UNITED STATES PATENT AND TRADEMARK OFFICE

APPLICATION NO.	FILING DATE	FIRST NAMED INVENTOR	ATTORNEY DOCKET NO.	CONFIRMATION NO.
09/982,837	10/22/2001	Su Seok Choi	054358-5009	8389

<b>Office Action Summary</b>	<b>Application No.</b> 09/982,837	<b>Applicant(s)</b> CHOI ET AL.	
	<b>Examiner</b> Tarifur R Chowdhury	<b>Art Unit</b> 2871

## DETAILED ACTION

**FIG. 1**

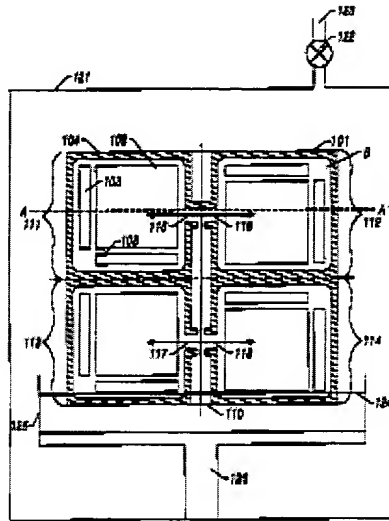
5. Yamazaki discloses and shows in Figs. 1 and 2, a liquid crystal display device comprising:

- a thin film transistor substrate (201), on which a plurality of data lines and gate lines are positioned perpendicular to each other;
- a plurality of pixel electrodes (102) formed near intersections of the data lines and the gate lines;
- a color filter substrate (202) positioned parallel to the thin film transistor

substrate (201), including a color filter layer (203), a black matrix and a common electrode (205) formed thereon;

- a polymer wall arrangement formed on the thin film transistor substrate dividing the substrate into a plurality of liquid crystal panels (col. 4, lines 1-6); and
- at least one liquid crystal injection opening formed on each panel of the plurality of liquid crystal panels

Further, it is clear from Fig. 1 of Yamazaki that at least one polymer wall is formed parallel to a side of the substrate.

Yamazaki also shows that spacer (206) is formed in the substrate.

**FIGURE 2**

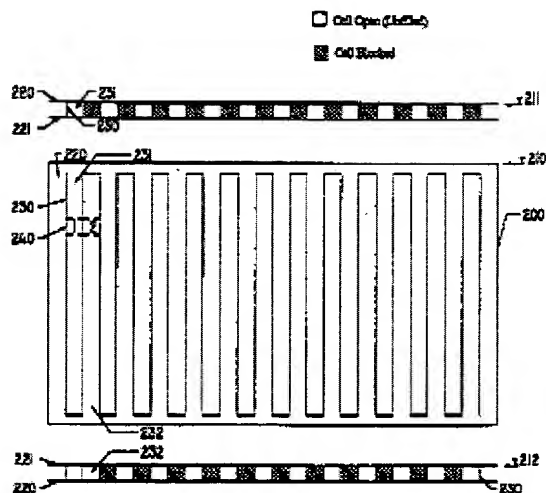
9. The AAPA described in the present application discloses and shows in Fig. 1, a liquid crystal display device comprising:

- a thin film transistor substrate (20), on which a plurality of data lines (23) and gate lines (22) are positioned perpendicular to each other;
- a plurality of pixel electrodes (25) formed near intersections of the data lines and the gate lines;

- a color filter substrate (10) positioned parallel to the thin film transistor substrate (20), including a color filter layer (12), a black matrix 913) and a common electrode (14) formed thereon;

The AAPA described in the present application differs from the claimed invention because it does not explicitly disclose the claimed polymer wall arrangement that is dividing the substrate into a plurality of liquid crystal panel and that at least one liquid crystal injection opening is formed on each panel of the plurality of liquid crystal panels.

Ma discloses a liquid crystal display device including a polymer wall arrangement that is dividing the substrate into a plurality of liquid crystal panels and each panel has at least one liquid crystal injection opening (col. 2, lines 5-10; col. 4, lines 36-38). Ma also discloses that such an arrangement is advantageous since it enhances manufacturability (col. 2, lines 11-12).
